# Eskal

BULLETIN 16

SUBJECT: Scrapper Fingers, Guard Spring and Wire on Casting Chute.

**SUBJECT:** Gear Breakage on a Limited Number of Eska Built Neutral Shift and Non-Shift Models

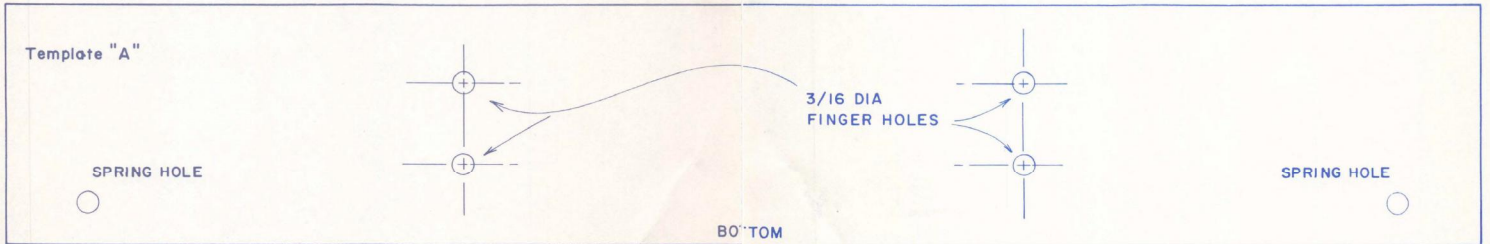
**PROBLEM:** During early production of above 1974 models, a limited number of Shear Pin, Part No. 96284, Pinion Gear, Part No. 96721, and Bevel Gear, Part No. 96016, were out of specifications. When the combination of the above was assembled into a single outboard, gear breakage could occur when striking an underwater object.

**SOLUTION:** If you disassemble a gear box and find the gears stripped and the shear pin bent, replace gears and shear pin. File warranty using this bulletin as authorization. Normal warranty period and condition still applies upon completion of repair, as stated in Div. 2, Sec. 3, Page 1-C-1, of your Service Manual.

Figure 1

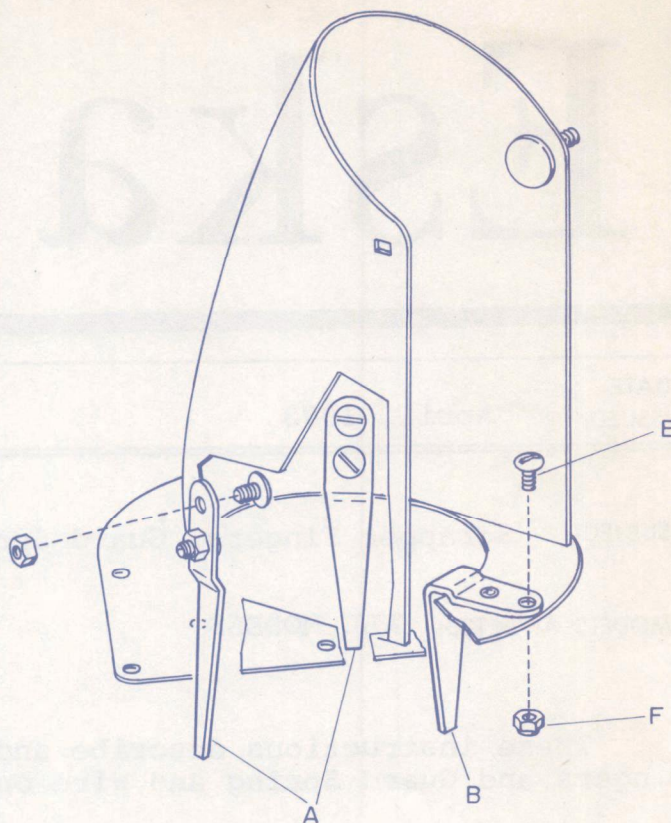
Step 5. Install two (2) back (Key A) and one (1) front scrapper fingers (Keys B) using five (5) screws (Key E) and nuts (Key F) as shown in Figure #1.

Figure 2

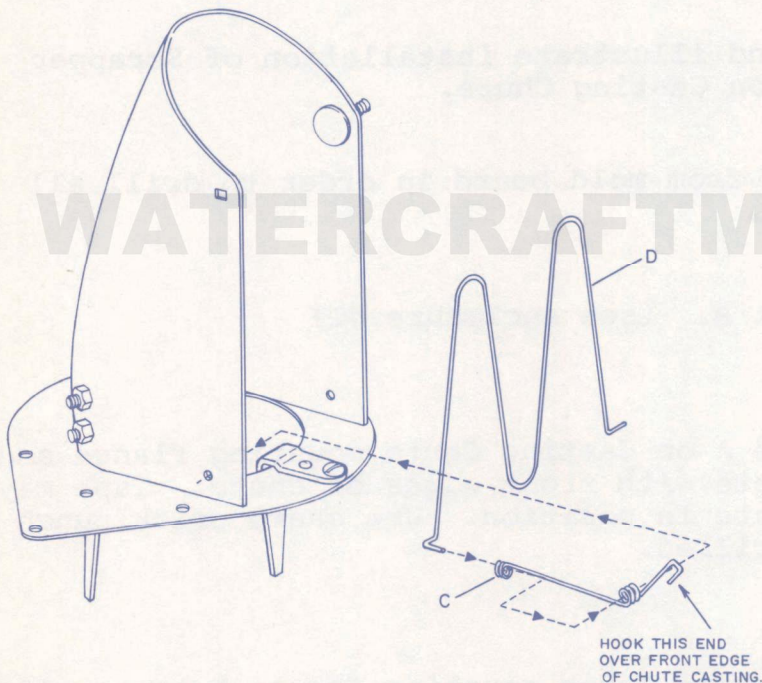
Step 6. Install Guard Spring (Key C) on guard wire (Key D) as shown in Figure #2.

Enclosure #1

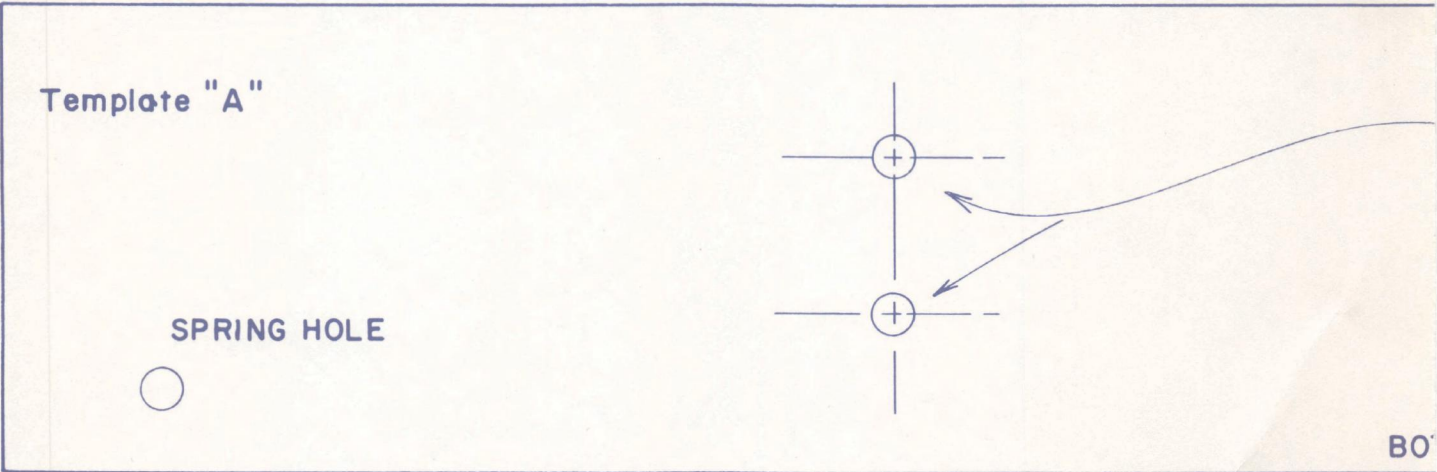
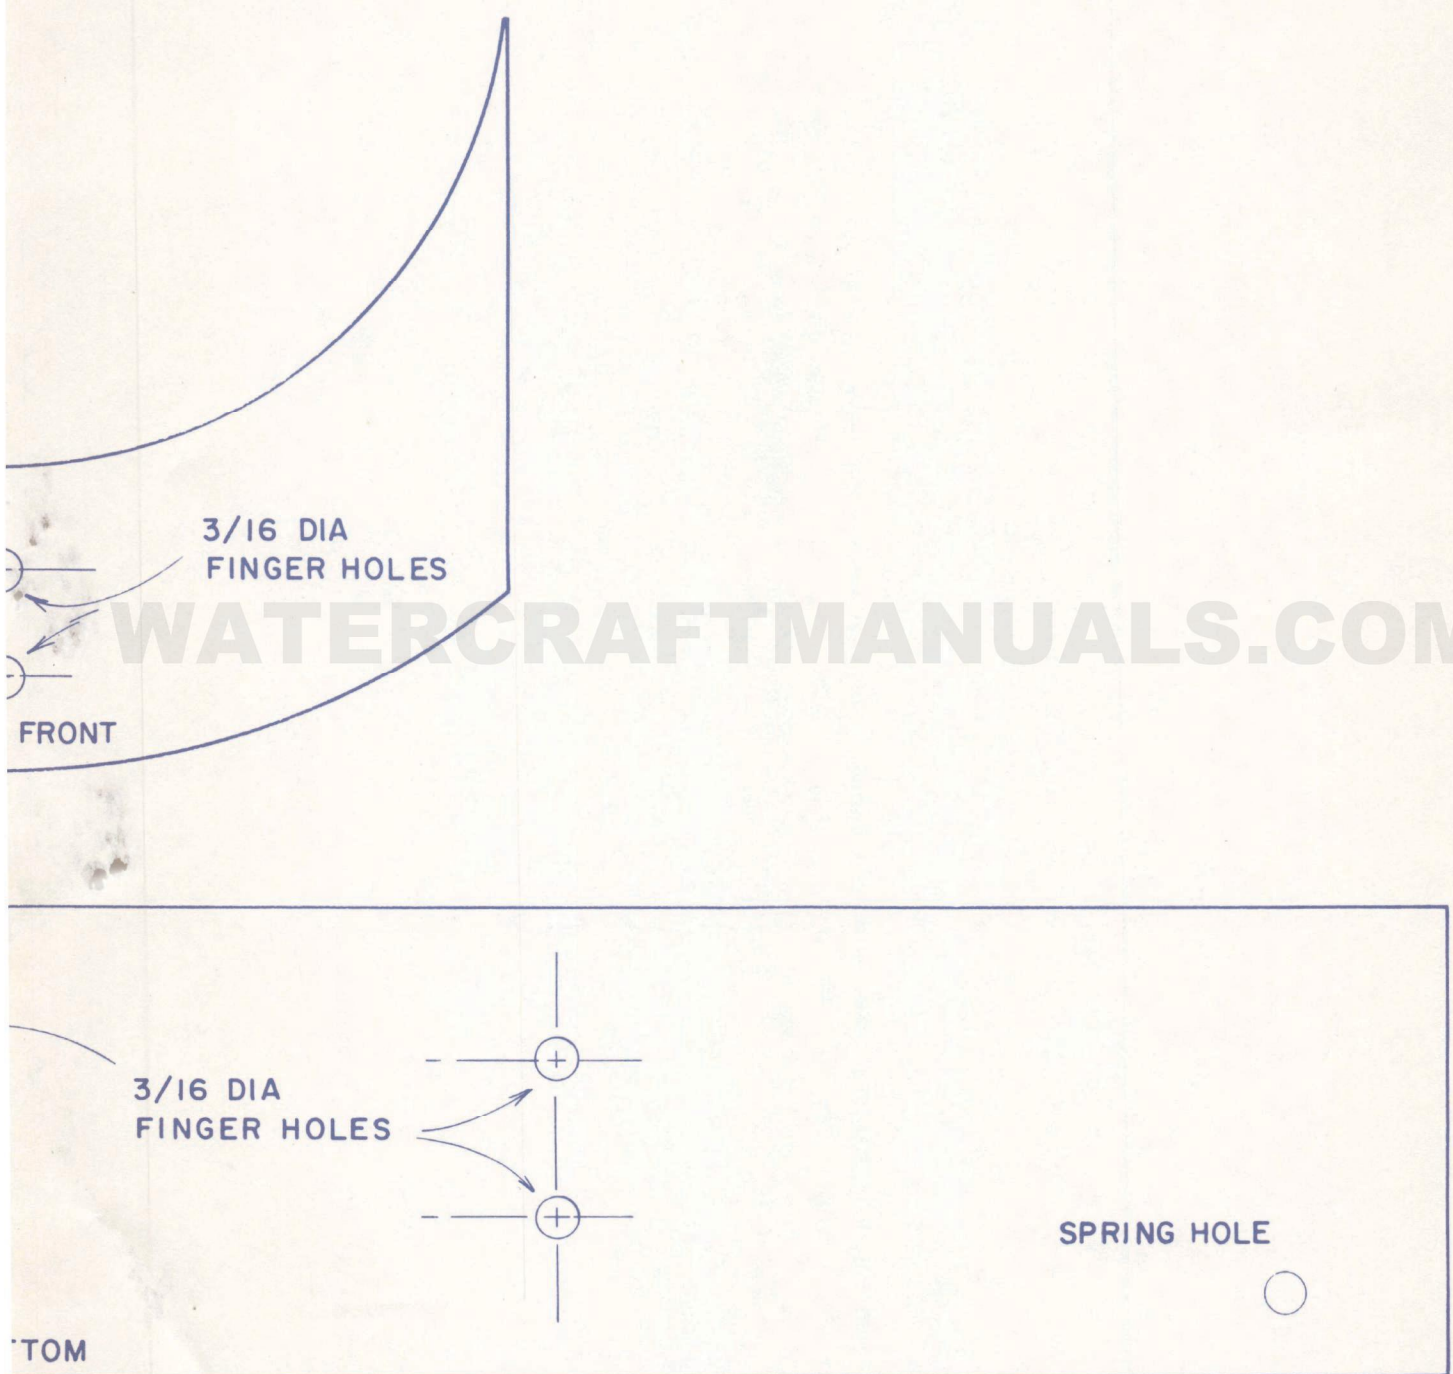
To install fingers use 3/16 drill and drill holes as indicated on templates.  
Place fingers in position and tighten screws with locknut.

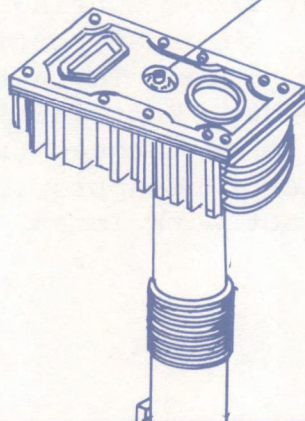
When removing water tube, Part #96549, from mounting plate, a new water tube, Part #96549, must be installed. Threaded portion of the water tube has been flared to secure to mounting plate. To install new water tube, secure mounting plate with Part #2835 Nut, Part #4849 Flat Washer, and Part #96168, Viton Seal Washer. Nut to be torqued from 23 to 25 inch pounds. Use taper punch to flare water tube approximately 3 degrees to insure proper fit so that it will not work loose.

Figure 1

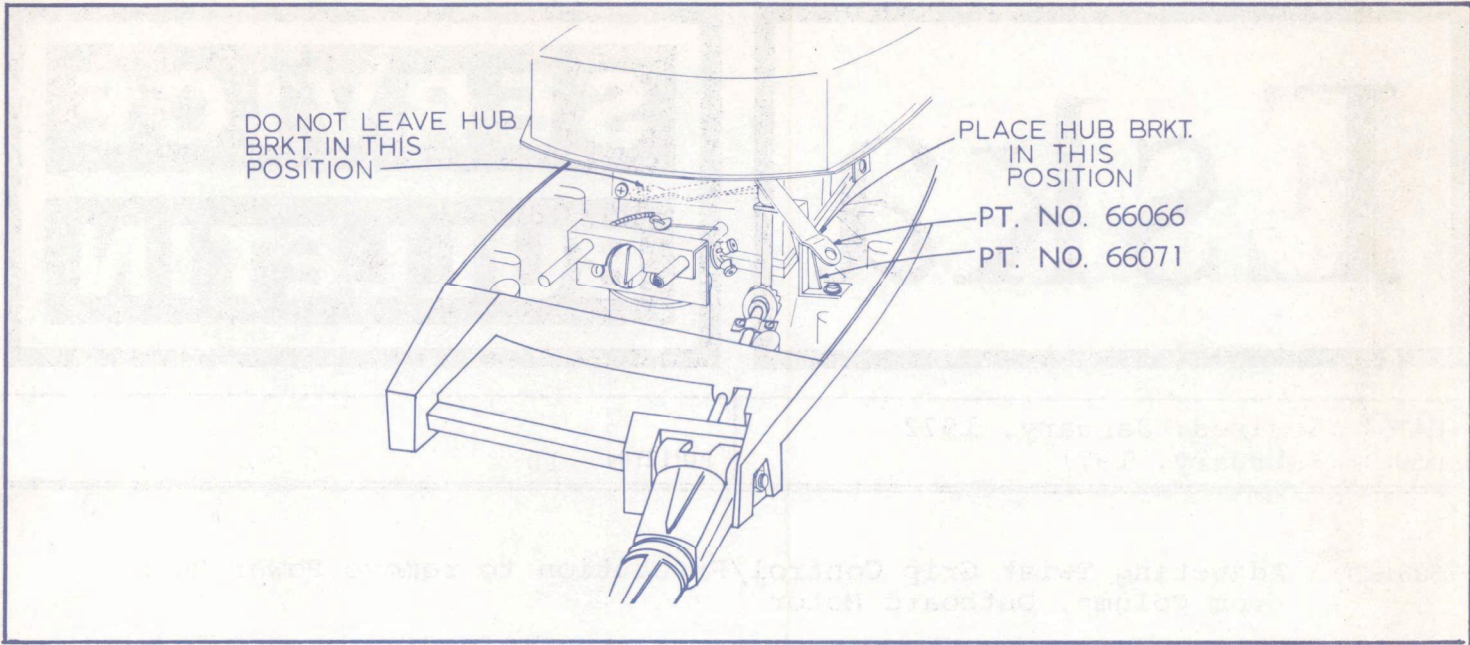
- A. Twist Grip Control must move with ease, but a drag should be noticeable to hold desirable speed without holding on to Twist Grip.
- B. When removing power head from column assembly, caution must be used to avoid unnecessary breakage of Twist Grip Control parts. Recommend throttle be in full-throttle position. This allows throttle hub bracket, Part #66066, and support bracket, Part #66071, to give clearance when removing power head. Always remove retaining ring, Part #7427, and rivet, Part #7607, to disengage the power head throttle control lever from the Twist Grip Control. (See Fig. 1)

Figure 2

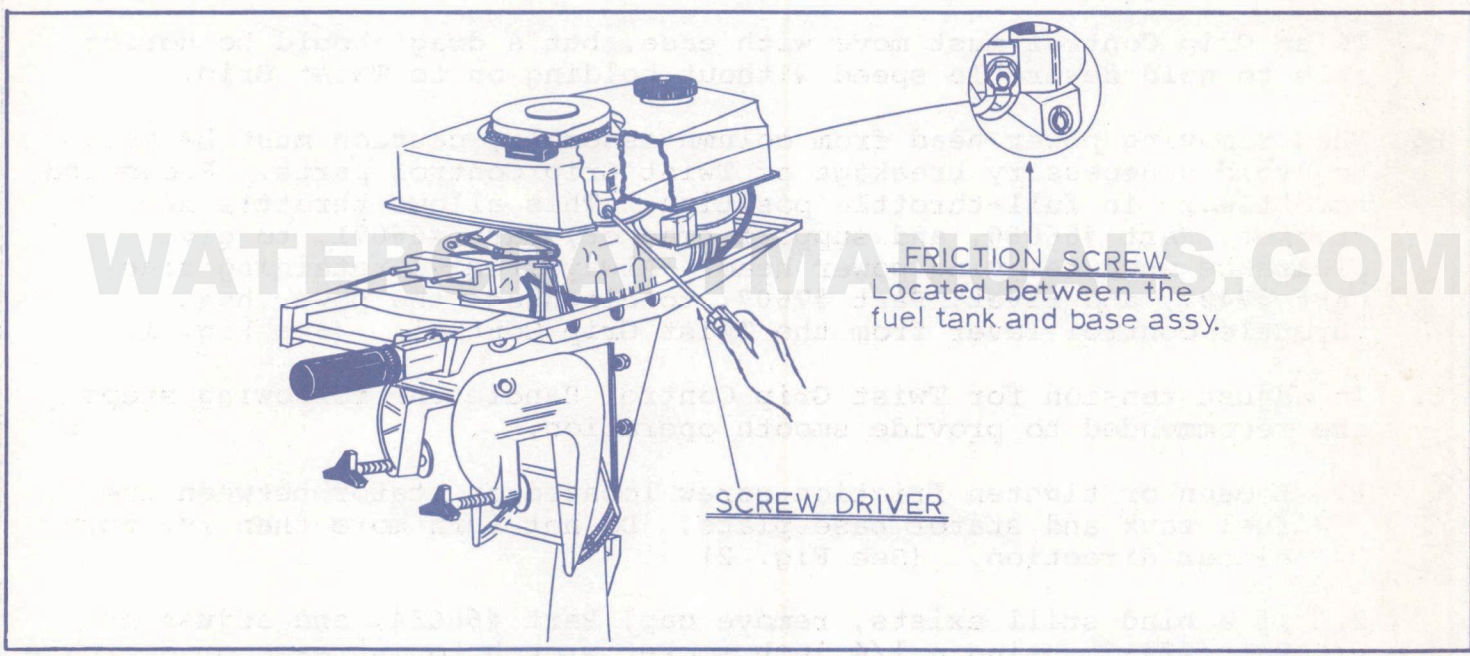
- C. To adjust tension for Twist Grip Control Handle the following steps are recommended to provide smooth operation.
1. Loosen or tighten friction screw located on stator between the fuel tank and stator base plate. Do not turn more than 1/2 turn either direction. (See Fig. 2)

Figure 3

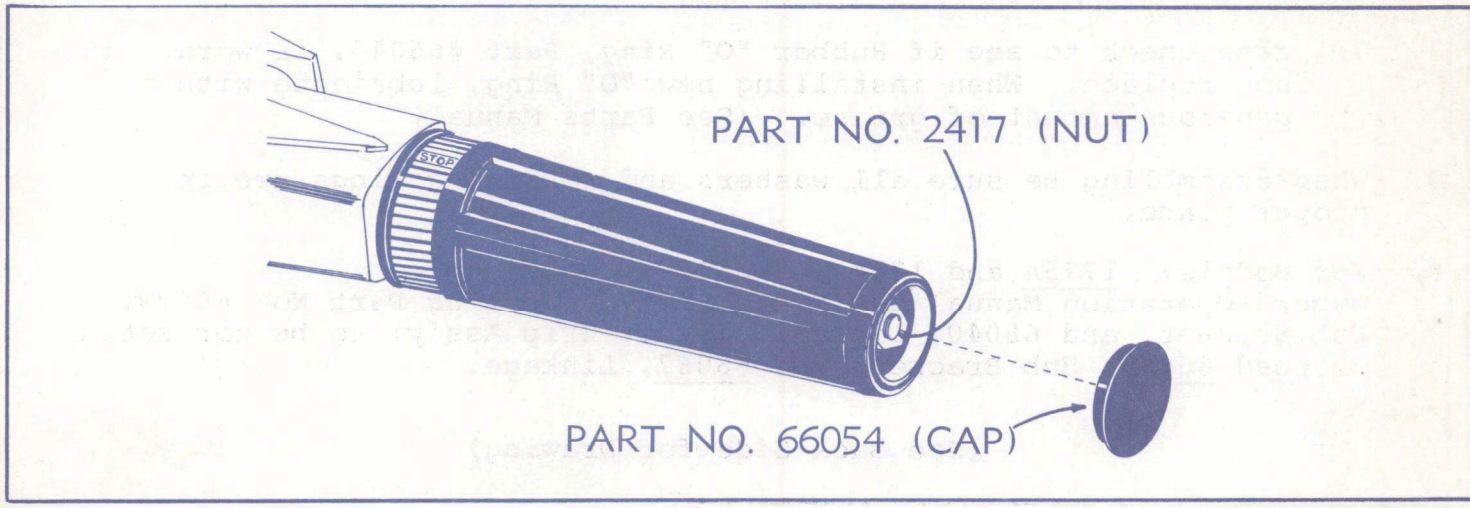
2. If a bind still exists, remove cap, Part #66054, and adjust nut, Part #2417, using a 1/4 inch socket wrench to increase or decrease drag. (See Fig. 3)

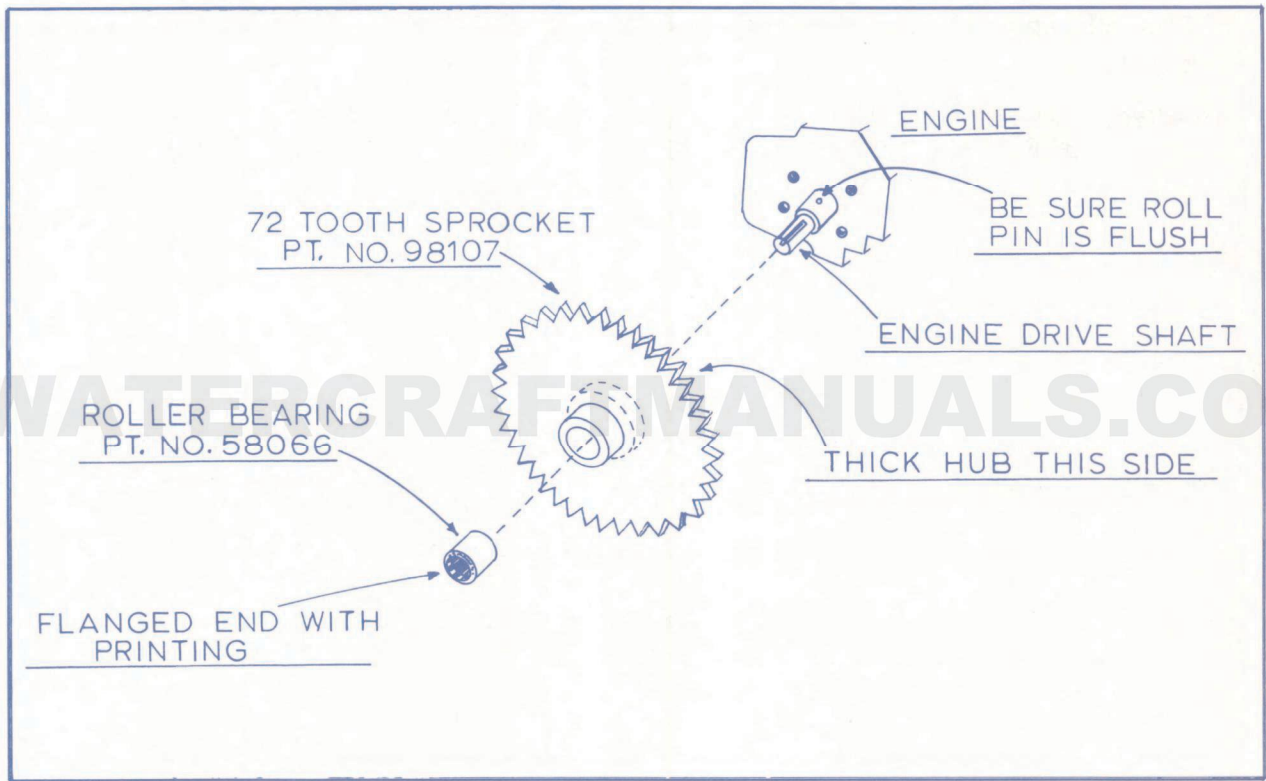
To install clutch roller bearing, Part #58066, make sure the flange side indicating printing is pointed toward end of crankshaft and not toward engine block.

Be sure roll pin is counter sunk below the surface on both sides of shaft.

Seventy-two (72) teeth sprocket, Part #98107, thick hub side to face toward Engine Block.

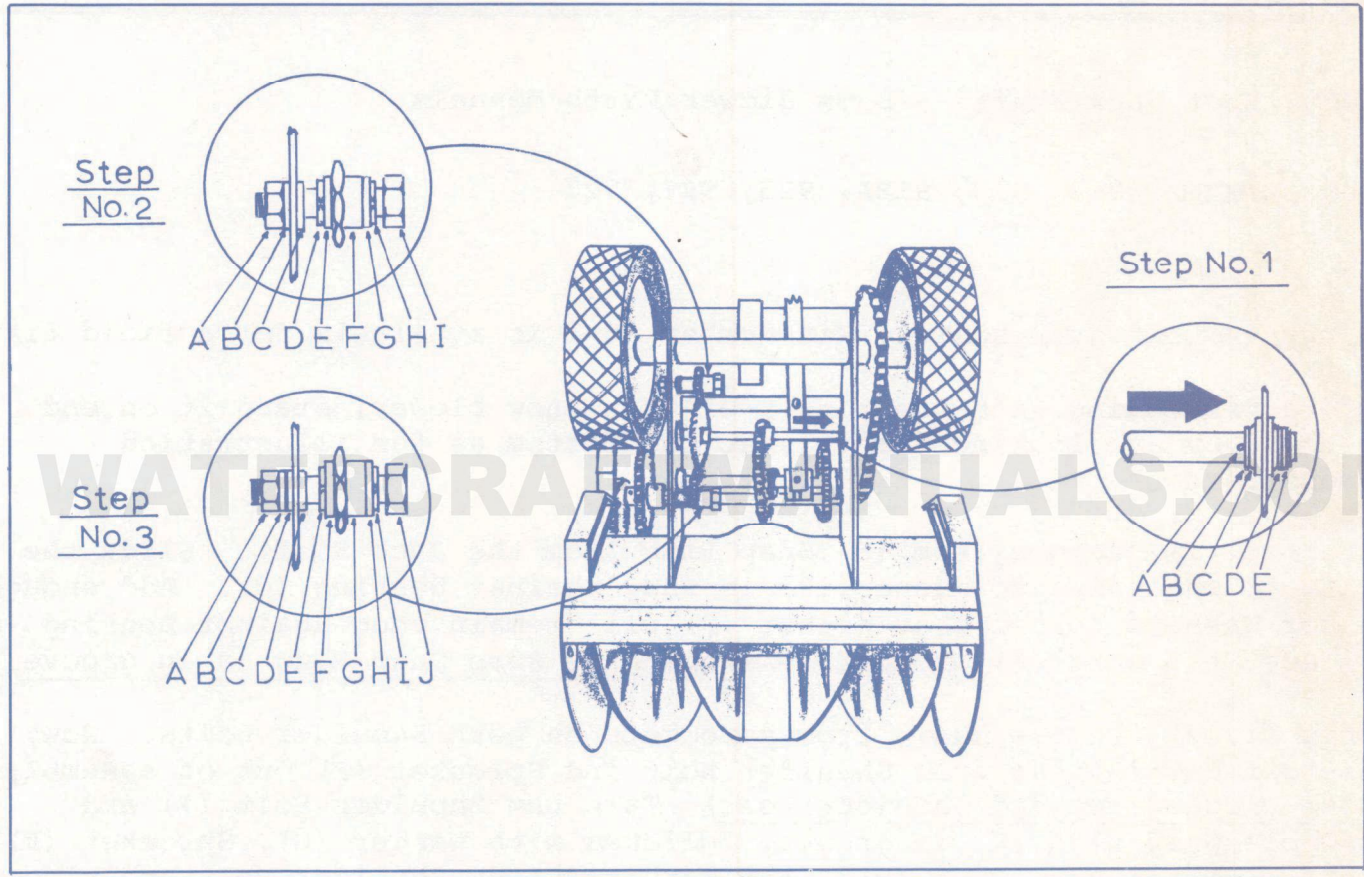
(Step No. 1) Remove Item (E) Snap Ring from the Jack Shaft. Slide the shaft to the right so Washer (B) is snug against Bearing (C). Add enough Spacer Washers (D) so that Washer (B) will remain snug against Bearing (C). Replace Snap Ring (E) on Shaft. (Note-Make sure Snap Ring is in groove.)

(Step No. 2) Remove chain from sprockets on both Shoulder Bolts. Now, take off Nut (A) and pull Shoulder Bolt and Sprocket (F) out of assembly. (Note-Discard removed Shoulder Bolt) Take new Shoulder Bolt (I) and assemble Snap Ring (H) in groove, followed with Washer (G), Sprocket (F), Washer (E) and Snap Ring (D). Add Washer (C) on Shoulder Bolt and place entire assembly back in Snow Blower. Assemble new Washer (B) and Nut (A) and tighten securely.

(Step No. 3) Step No. 3 is performed the same as Step No. 2, except for the adding of one Serrated Washer (C) under Washer (B).
